**NORTHEAST FRONTIER RAILWAY
(CONSTRUCTION)**

No. W/207/CON/Land/Sivok-Rangpo/Forest land (Kurseong)/317 Date: 24.02.2021

Sub: Diversion of 13.512 Ha of forest land (0.5089 Ha under Kurseong Forest Division+ 2.7945 Ha under Darjeeling Forest division+ 10.2086 Ha under Kalimpong Forest Division) for construction of Sivok-Rangpo New Broad Gauge Railway line from Sivok in West Bengal to Rangpo in Sikkim in favour of Northeast Frontier Railway, New Jalpaiguri.

Figure-3:- Typical Gabion Wall Cross-section

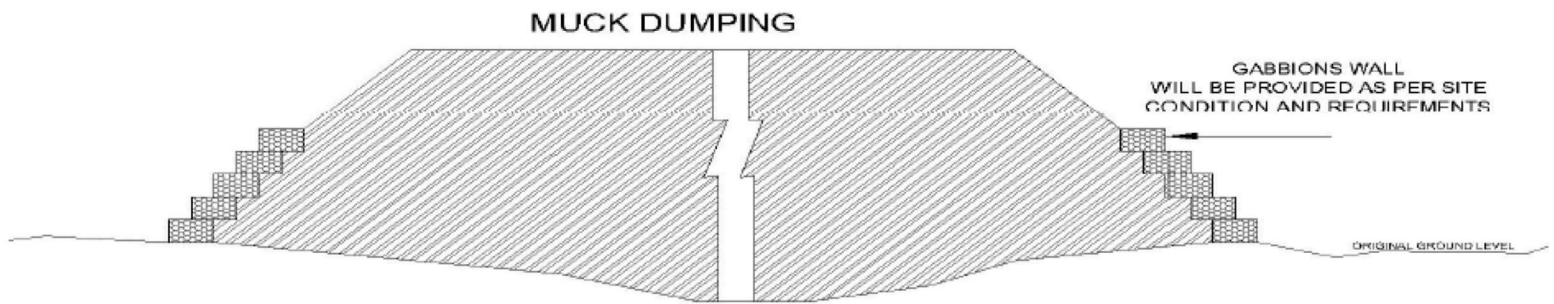
2	Details of vulnerability of forest area to erosion due to project for which digital elevation model maps and hydrological maps are required. Further robust soil and moisture conservation works proposed in the area proposed for diversion along with the detailed construction/land use planis required to ensure protection of the adjoining areas, especially NH10 and banks of river Teesta.	The six patches of forest land which were proposed for diversion are to be used for various purposes, such as muck dumping yard (3 patches), Station building and Staff quarters (2 Patches) and 1 patch for development of infrastructure for Railway. The sites have been jointly inspected by you and there is no such issue of erosion of forest area. Gabion wall shall be constructed all along to contain the muck in the designated areas and area identified for infrastructure development area. Properly designed earth retaining structures will be constructed at Station building, Staff quarter area so that these public assets remain functional for their design life circle.	The areas vulnerable to erosion has been taken care of by proper Shotcrete, gabion wall etc. Apart from that, site specific Soil moisture conservation plan if required shall be done in consultation with Forest Department.

Some of the drawing related to protection of hill slopes and photographs showing retaining wall erected at some places in the project for soil conservation is enclosed herewith for ready reference please.
